GOVERNMENT OF THE DISTRICT OF COLUMBIA
OFFICE OF PLANNING

FURTHER INFORMATION

SUBJECT: Zoning Commission Case No. 05-42; Final Report
Consolidated PUD and Map Amendment - Sibley Memorial Hospital.

Zoning Map

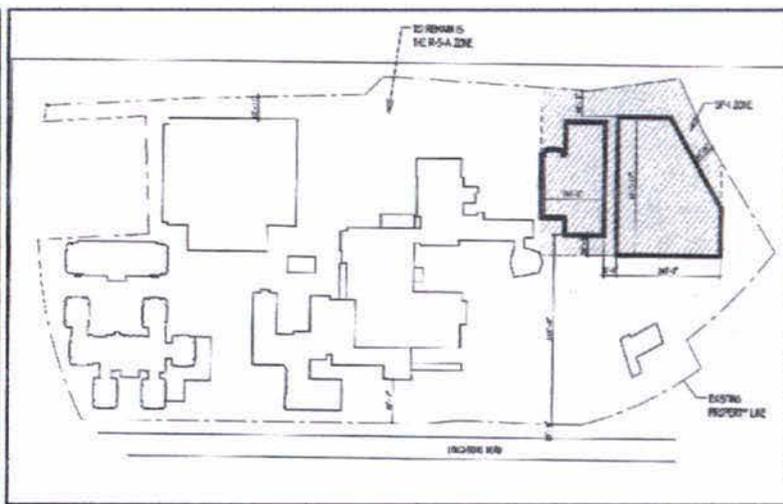
ZC 02-29¹ approved extension of the R-5-A zoning over a portion of the 8.54-acre parcel of land purchased by Sibley Memorial Hospital from the United States Government which was unzoned. A portion of this area would be included in the current proposal as shown in the following diagrams.
